Subject: **ADDENDUM NO. 7**

Project: **CENTER FOR MATERIALS AND MANUFACTURING SCIENCES, TROY UNIVERSITY MAIN CAMPUS-TROY ALABAMA**

Job #: **SSL# 18144**
BC# 2020416
PSCA#: 006P

Sheet Number:
LS2.0

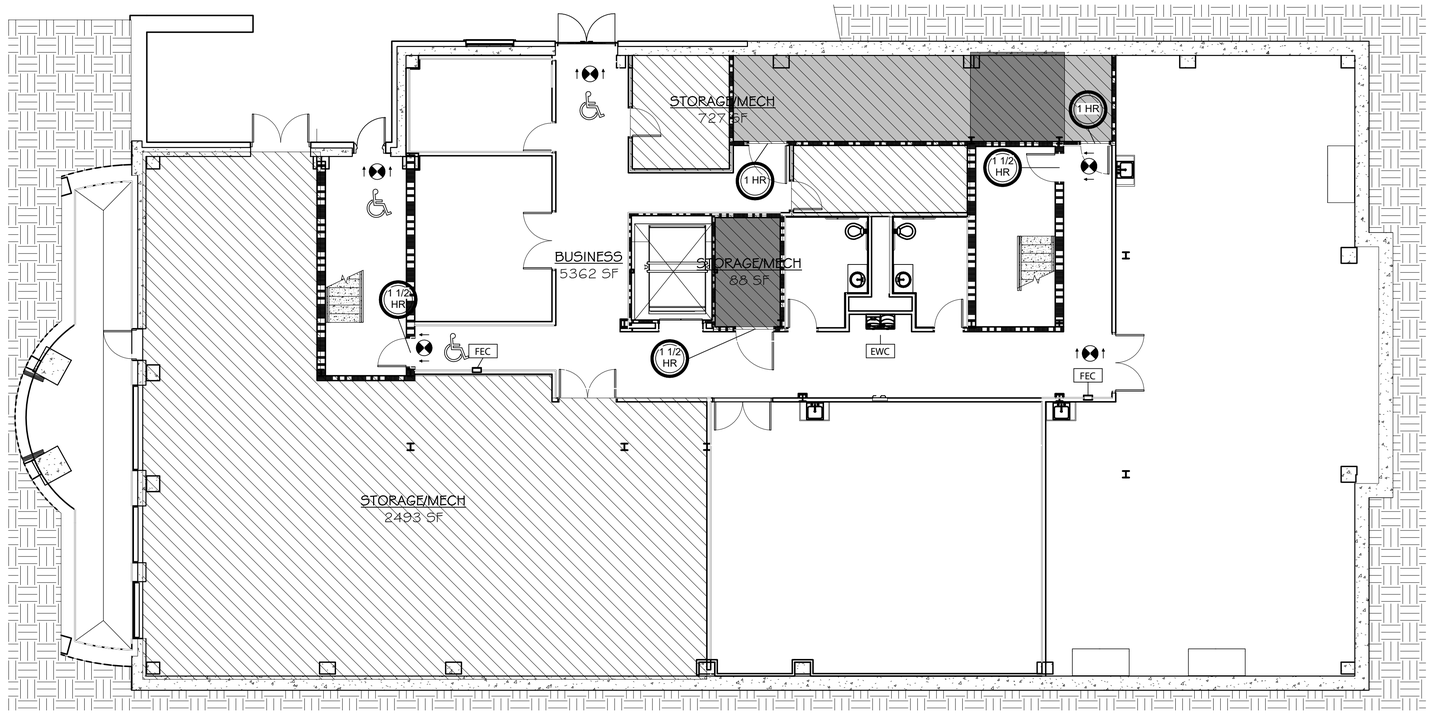
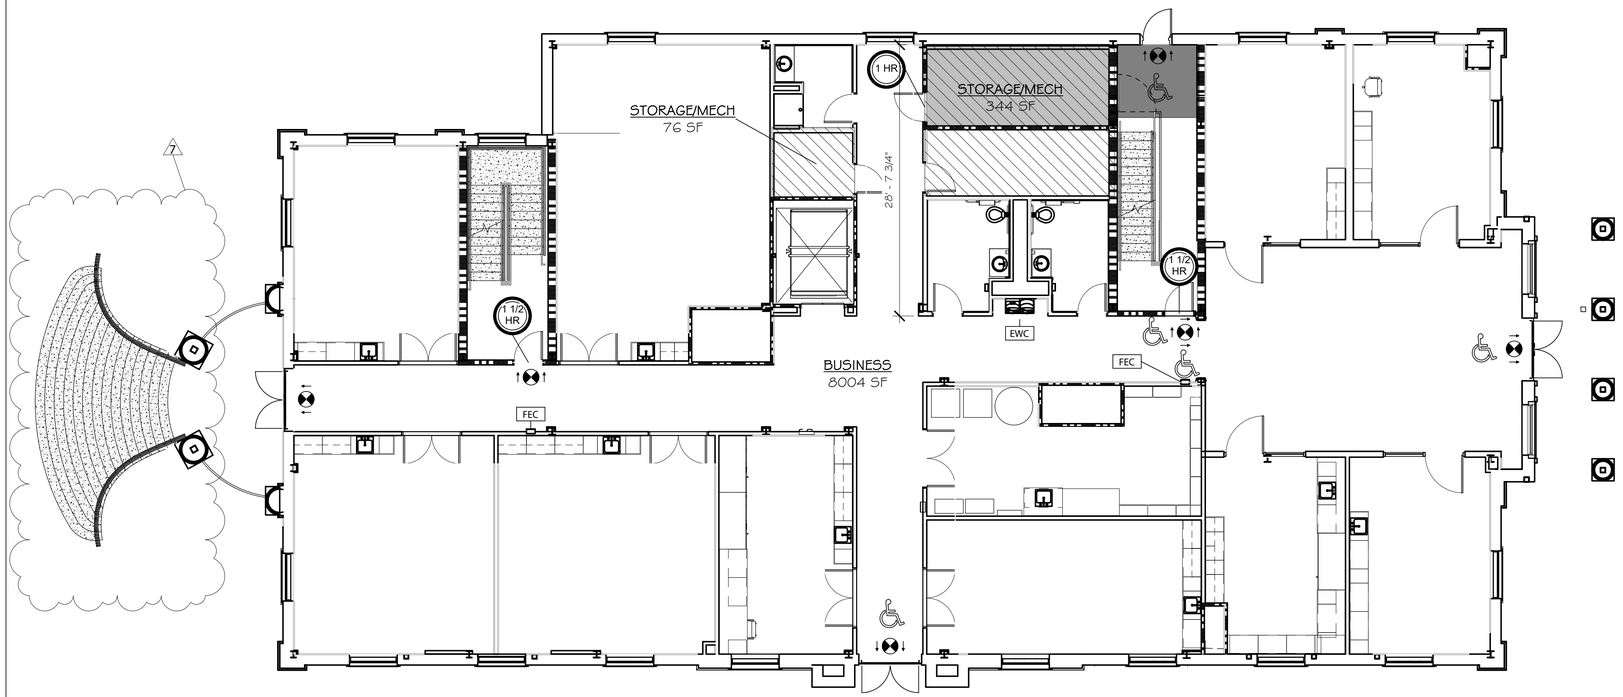
Item 2: Refer to attached Sheet LS2.0:
-Revise West stair footprint

Sheet Number
L1.0

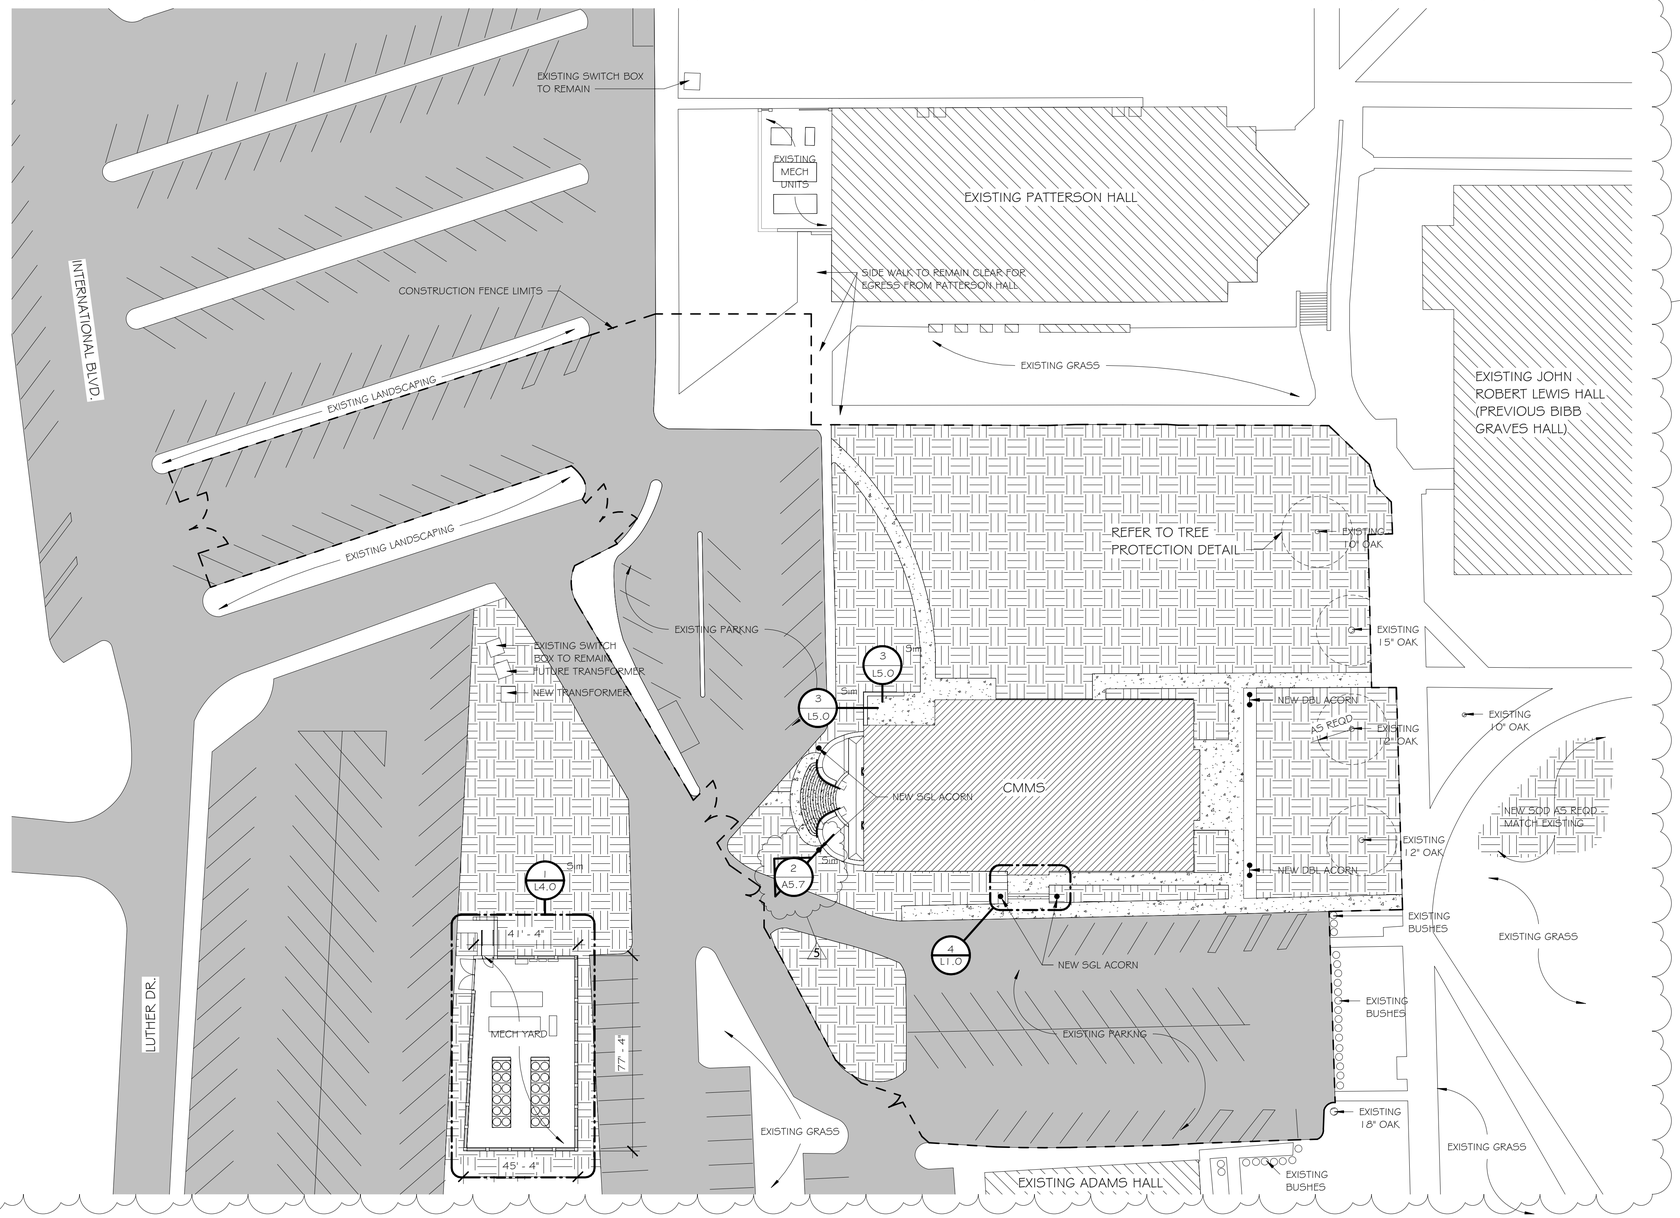
Item 3: Replace L1.0 with the attached L1.0:
-Move Mech Yard
-Revise West stair footprint
-Revise Construction Fence
-Add 2 Single Acorn lights

Sheet Number
L4.0

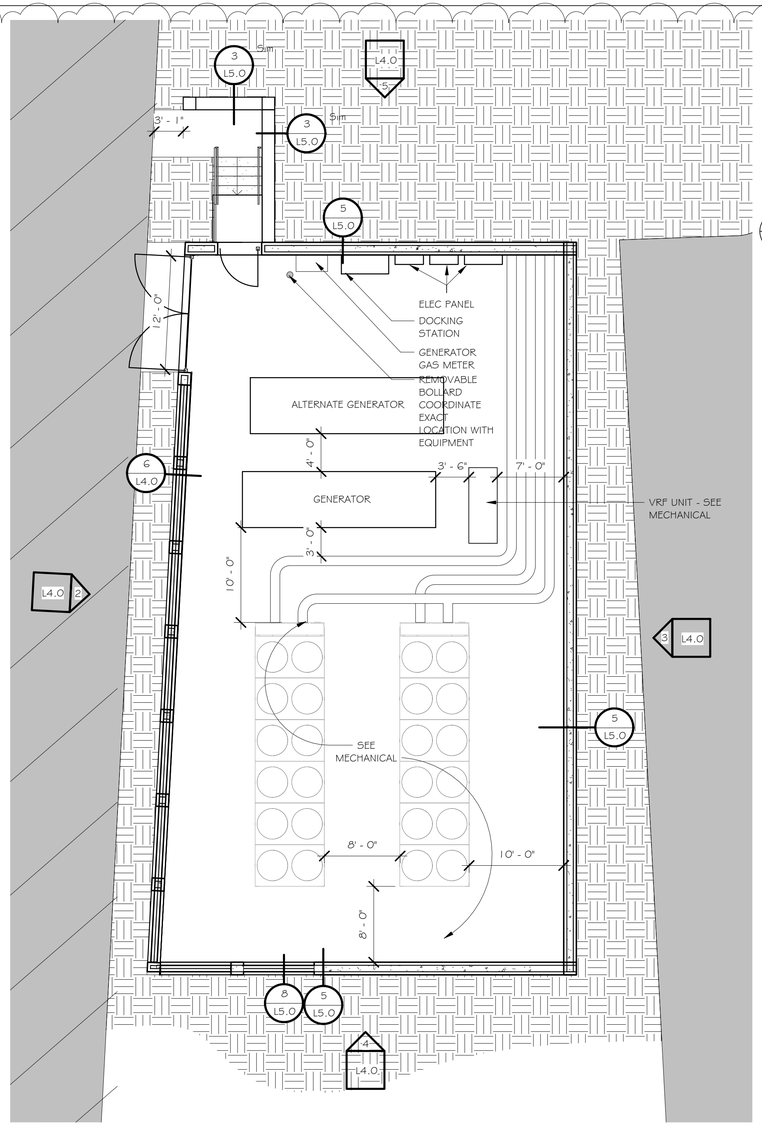
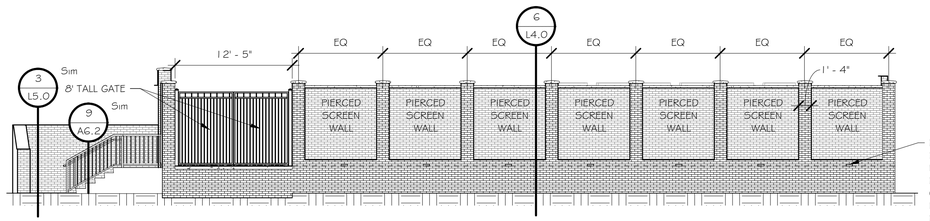
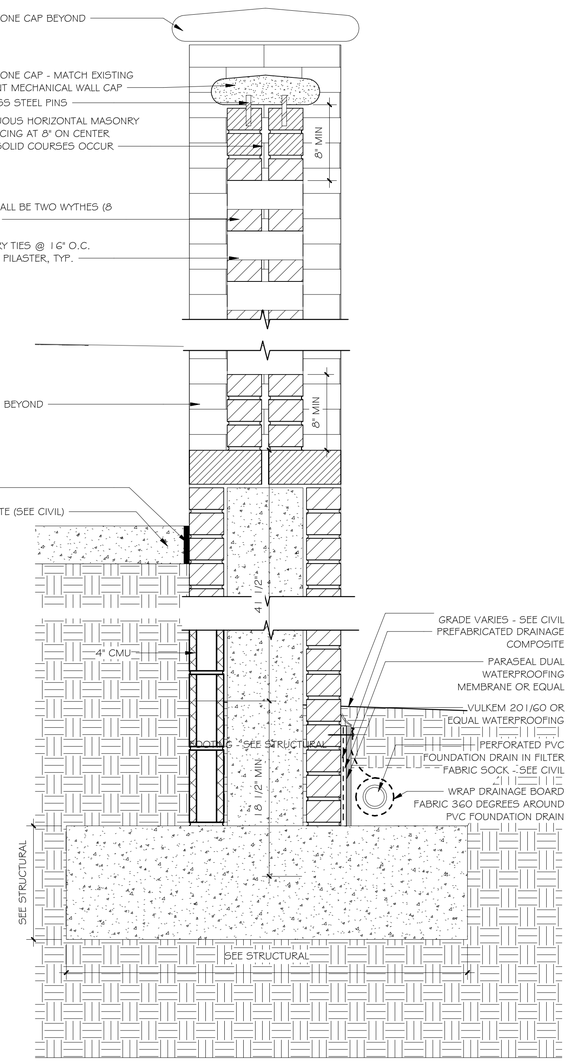
Item 4: Replace L4.0 with the attached L4.0:
-Move Mech Yard
-New Mech Yard Elevations
-New Mech Yard section detail

Sheet Number
A2.1

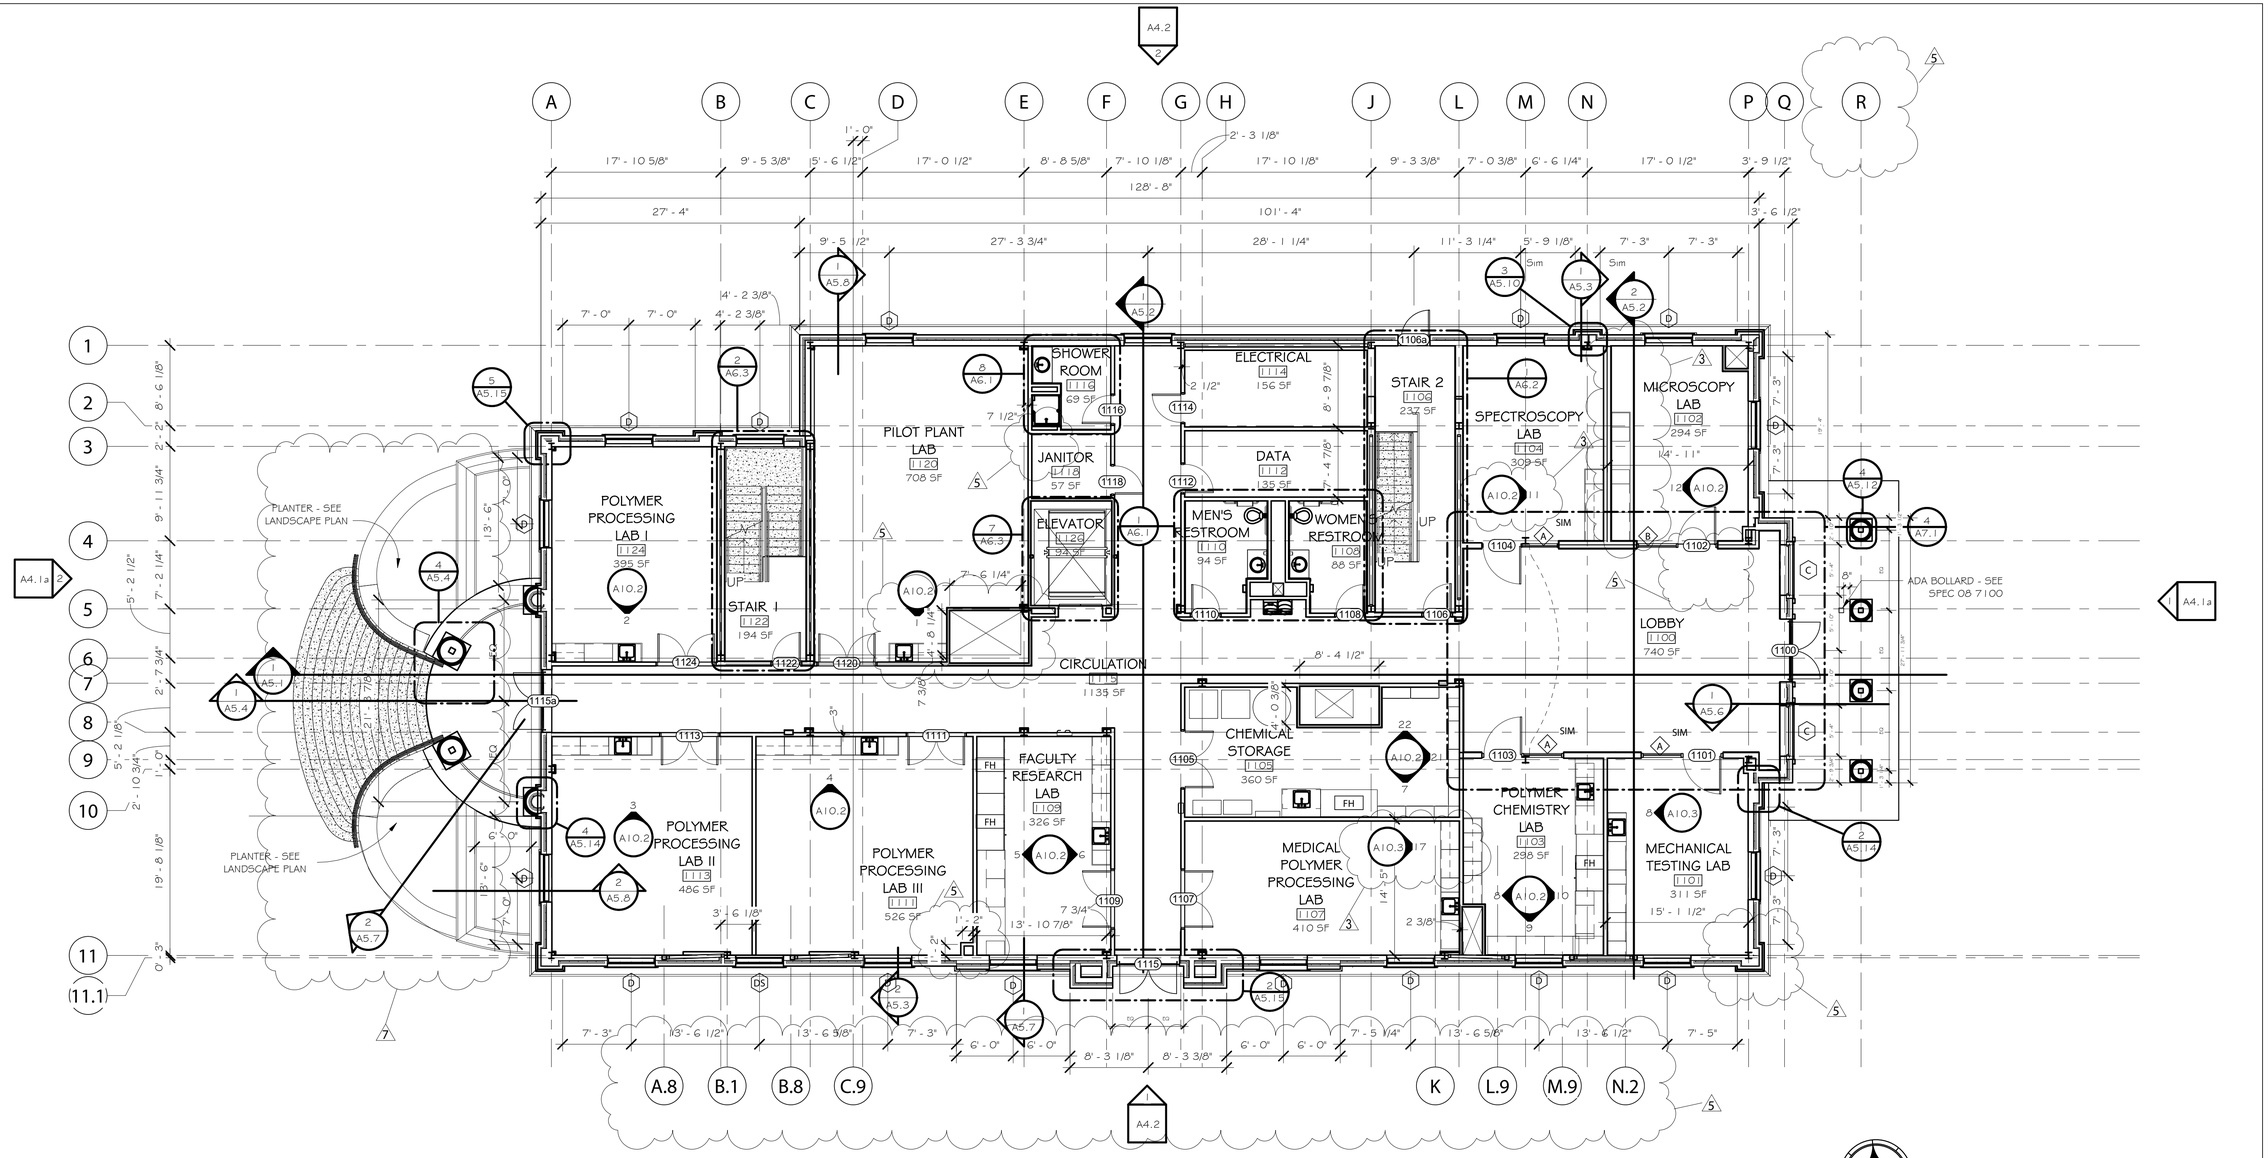
Item 5: Replace A2.1 with the attached A2.1:
-Revise West Stair footprint

Sheet Number
A2.3

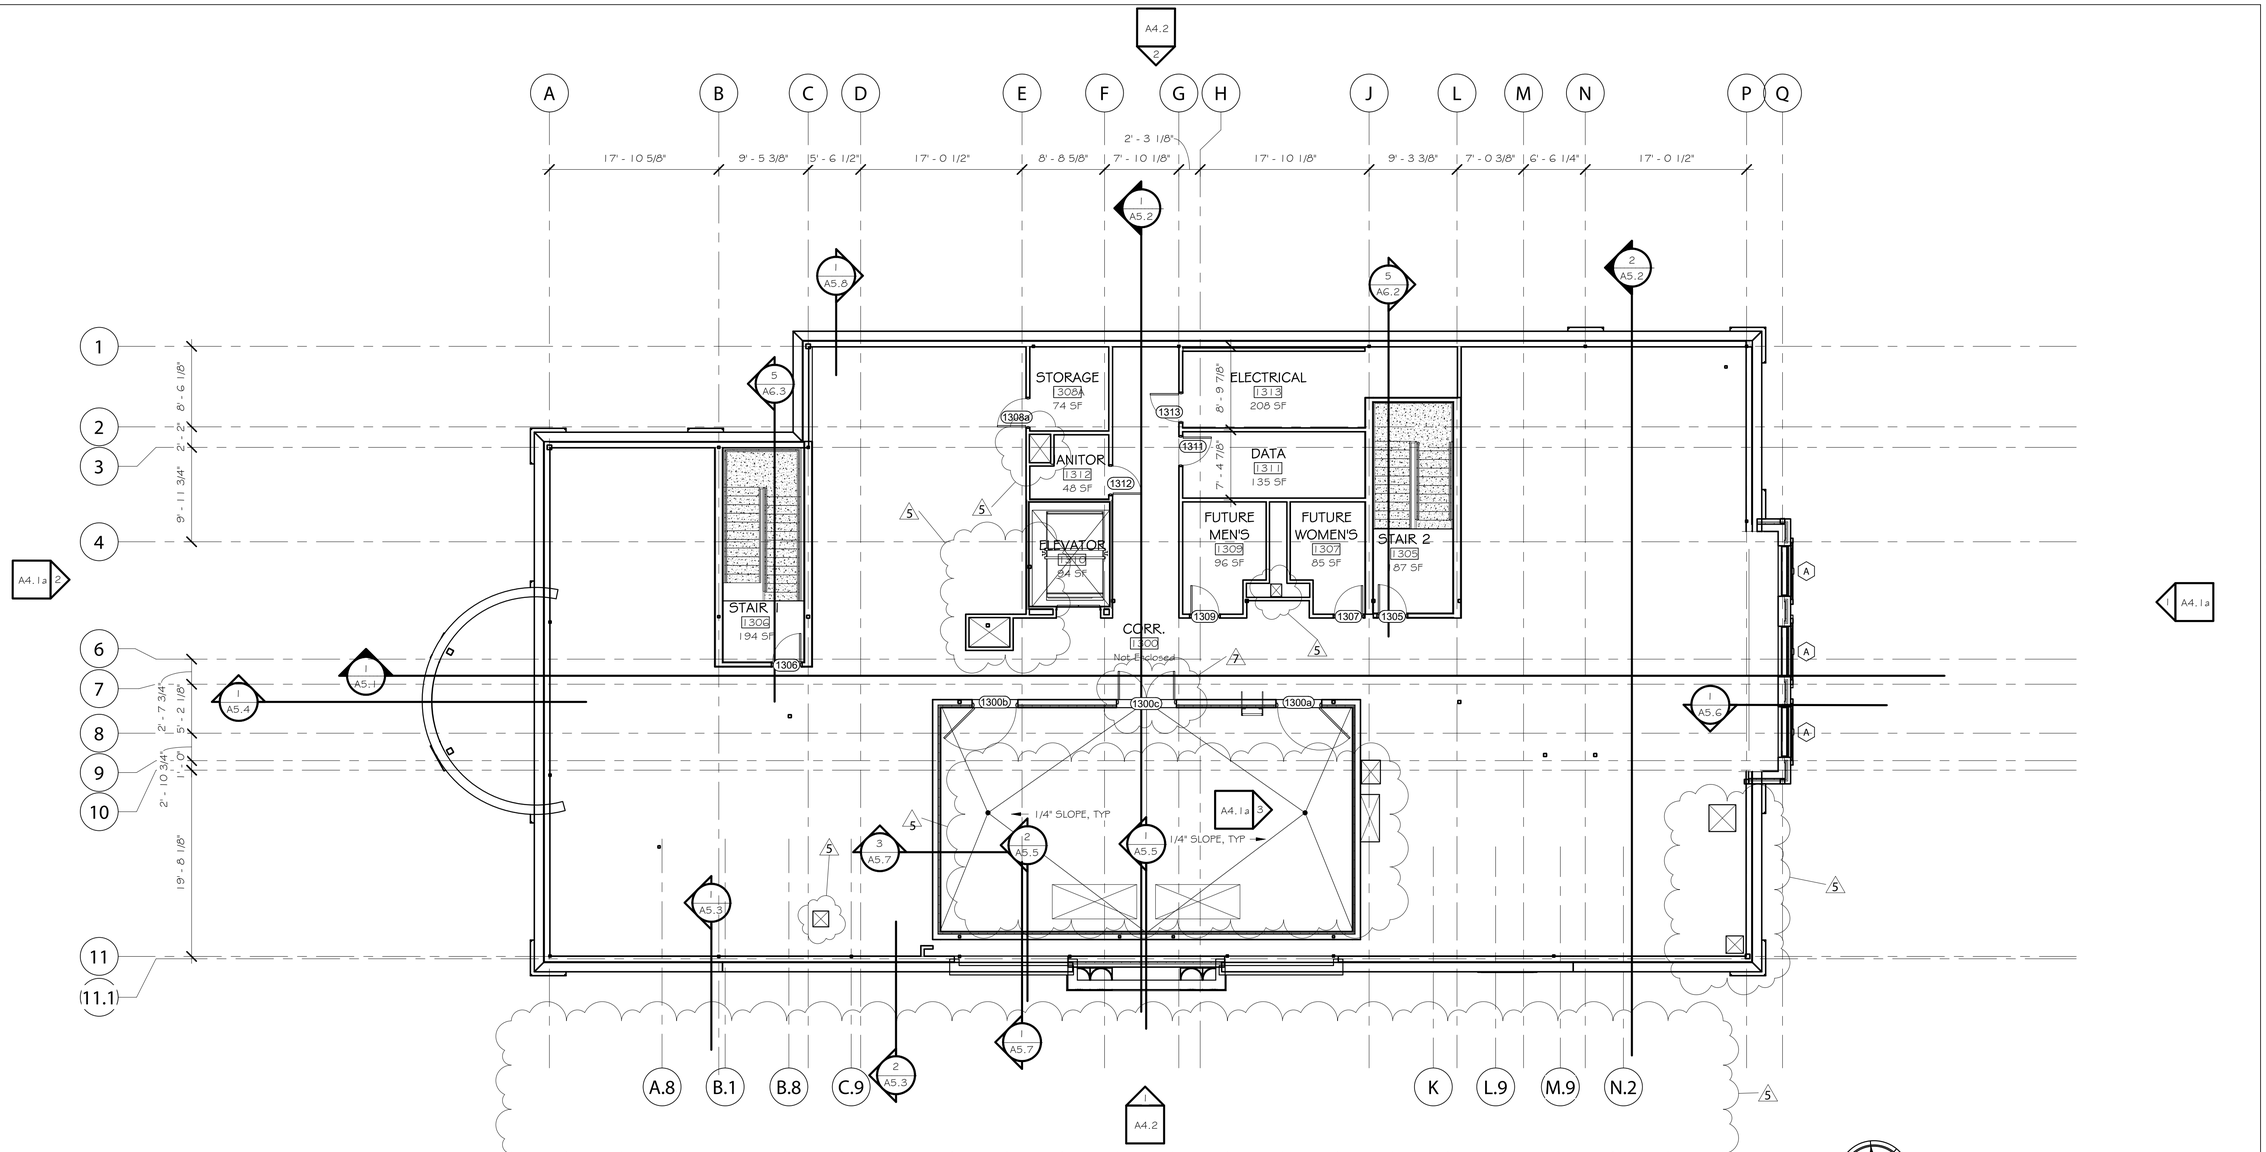
Item 6: Replace A2.3 with the attached A2.3:
-Add door 1300c
